ORIGINATION FORM

Proposed Revisions to a Standard Plans Index

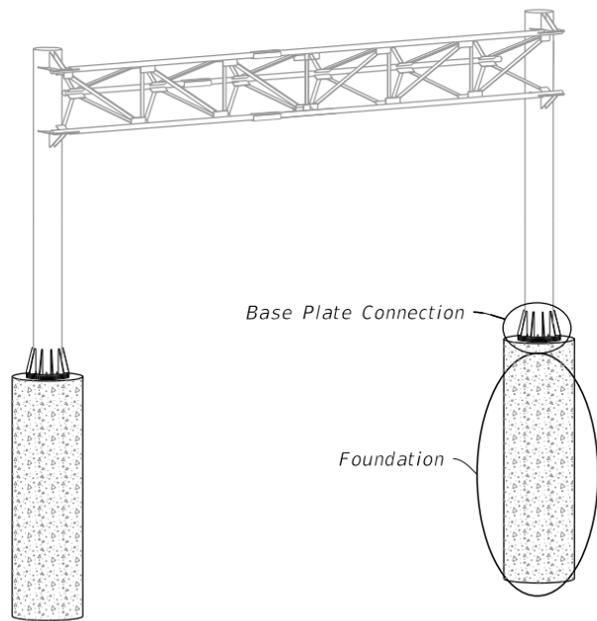
| <input checked="" type="checkbox"/> | <input type="checkbox"/> | Redline Mark-ups |
